UNITED STATES
NUCLEAR REGULATORY COMMISSION

SUBJECT: PROPOSED TASK INTERFACE AGREEMENT REGARDING THE TECHNICAL
ADEQUACY OF SUSQUEHANNA'S LEVEL/POWER CONTROL ACCIDENT
MITIGATION STRATEGY USED IN IMPLEMENTING THE EMERGENCY
OPERATING PROCEDURES

Enclosed are the sections of the licensee's Plant Specific Technical Guidelines (PSTG) that address the Level/Power Control strategy and the justification for the deviations from the BWROG EPGs. Also enclosed is the HCTL curve used by SSES and the justification provided to the NRC to address the concerns identified during the EOP team inspection.

1. Plant Specific Technical Guidelines (SSES-EPG) and Justification
2. Figure PC-1, Heat Capacity Temperature Limit
3. Justification for HCTL Provided by SSES to NRC

FIGURE PC-1

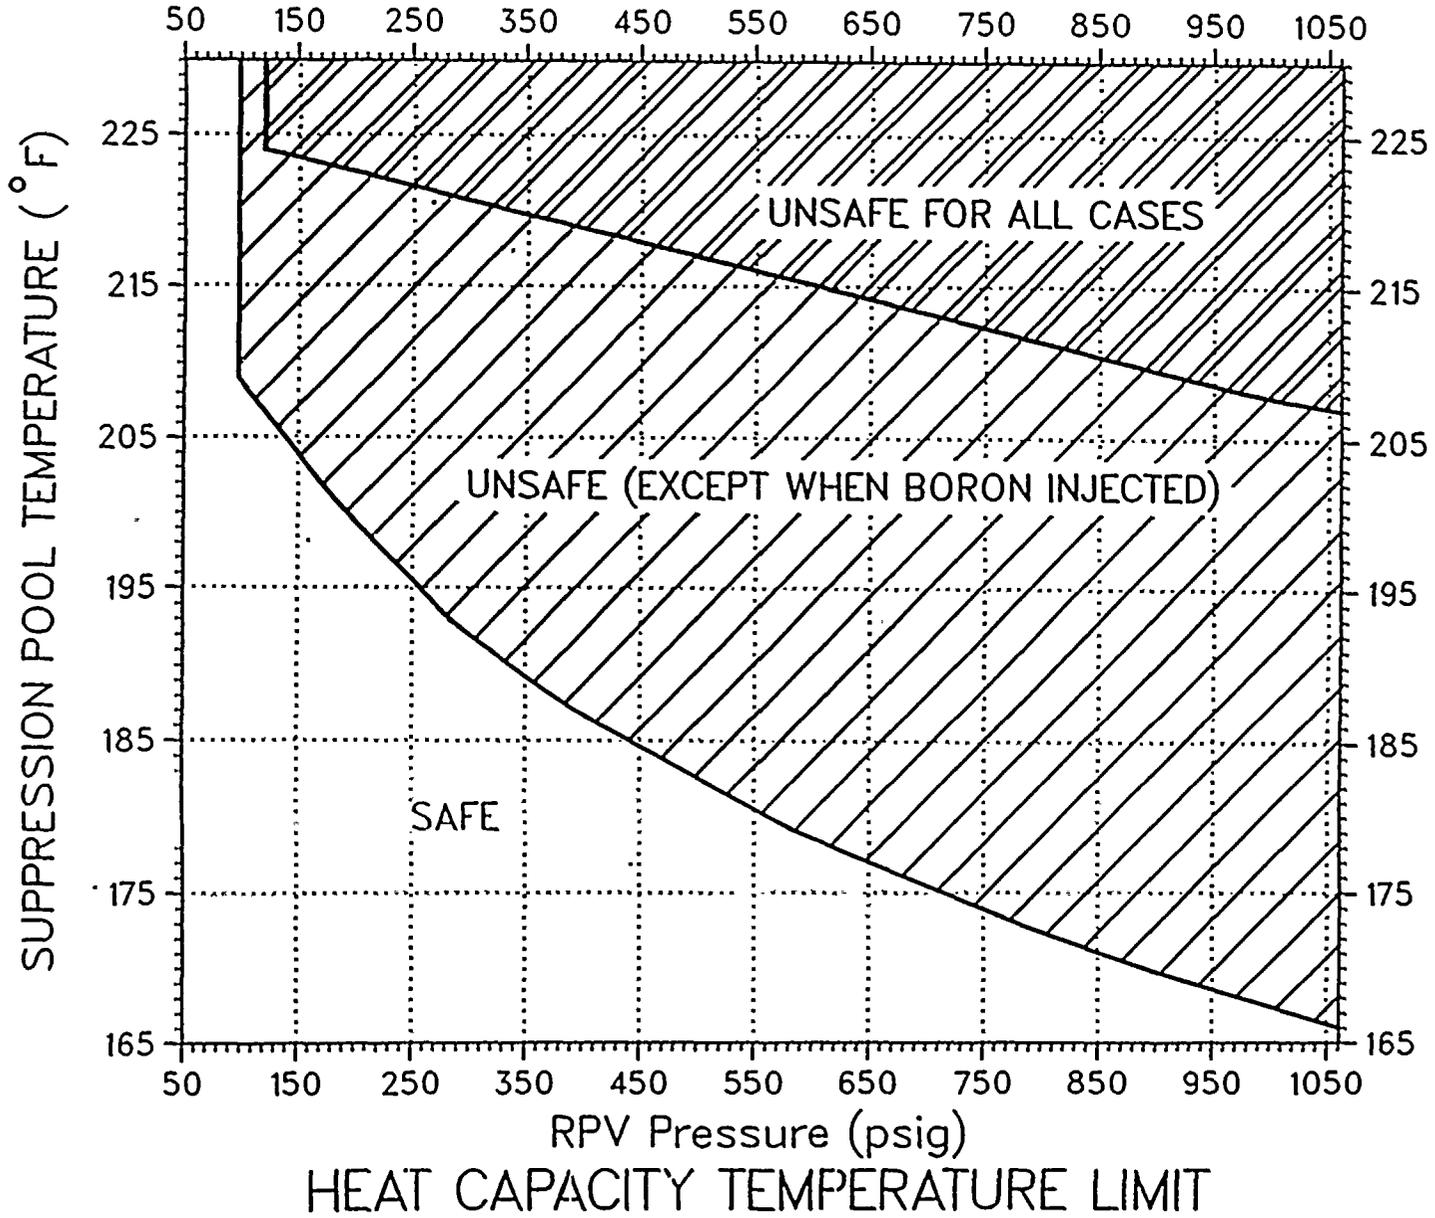
During the EOP team inspection conducted in April 1990 (Inspection Report Nos. 50-387/90-80 and 50-388/90-80), the inspectors questioned the technical adequacy of the Heat Capacity Temperature Limit (HCTL) curve. The HCTL curve that is used during ATWS conditions was determined based on two loops of suppression pool cooling in service and assumed a time to insert control rods by normal manual insertion. The inspectors questioned whether the curve was appropriate for use with only one loop of suppression pool cooling in service. The inspectors were also concerned that if control rod insertion or boron injection is delayed, the actions identified in the EOPs to reduce pressure may not be sufficient to reduce the energy input into the suppression pool and further reduction in reactor water level may be required.

Questions have been raised regarding the advisability of the SSES
level strategy during ATWS conditions. Specifically,
questions involved the Suppression Pool temperature Response with
less than 2 loops of Suppression Pool Cooling in service and with
delayed SBLC injection or delayed manual control rod insertion.
It has also been implied that because fewer than 2 loops of
Suppression Pool cooling may be available, or because SBLC
injection or manual control rod insertion may be delayed, an
appropriate strategy might be to reduce RPV water level to IAF in
order to reduce heat loads to the suppression pool.

These issues are addressed in section 1.7 of the PP&L IPE which
was issued in 1986, and were presented to the NRC in May, 1989.
The PP&L strategy regarding level control during ATWS has been to
try to preserve both the reactor core and the containment. As was
stated on page 7-71 of the 1986 IPE, we are concerned about
reactor instability which can be experienced at low RPV water
levels, due to the reduced natural circulation flow rate
associated with those low levels.

The SSES EOP's require initiation of SBLC before Suppression Pool
temperature reaches 110°F. The calculations done for the 1986
SSES IPE indicate that this pool temperature could be reached at
T=90 sec. However, even if SBLC is not initiated until T=120 sec.
in the worst case situation (i.e., 43 gpm SBLC flow (1 pump) and
core bypass), shutdown conditions will be reached before the
Suppression Pool reaches the ATWS HCTL (208°F).

In fact, in this worst-case scenario both the PP&L level control
and BHWROG level control methods allow hot shutdown conditions to
be reached with quite a bit of margin to the SSES ATWS HCTL.
However, the PP&L strategy also provides additional margin for the
reactor stability concern, and PP&L's use of a separate HCTL limit
for ATWS conditions reduces the likelihood for depressurizing a
critical reactor, which, as is described in the 1986 SSES IPE, is
also one of our reactor stability concerns.

Since the 1986 SSES IPE was issued, PP&L has continued to refine
its analytical ability in this area. Calculations which were done
in support of the latest IPE revision, and which are currently
being finalized reveal that even without any suppression pool
cooling in service, the PP&L ATWS water level strategy allows hot
shutdown conditions to be reached (based on SBLC injection flow of
43 gpm) before the PP&L ATWS HCTL is reached. At this point, a
single loop of Suppression Pool cooling will be sufficient to
maintain containment parameters below design limits. In the long
term, a complete on-going loss of containment heat removal
capability will eventually lead to containment failure regardless
of which ATWS water level strategy is followed.

In addition, these calculations also show that following
depressurization at the SSES ATWS HCTL, reactor power is decreased
sufficiently (due to the depressurization) to allow the manual
insertion of control rods and thereby achieve hot shutdown prior
to reaching containment overpressure conditions.
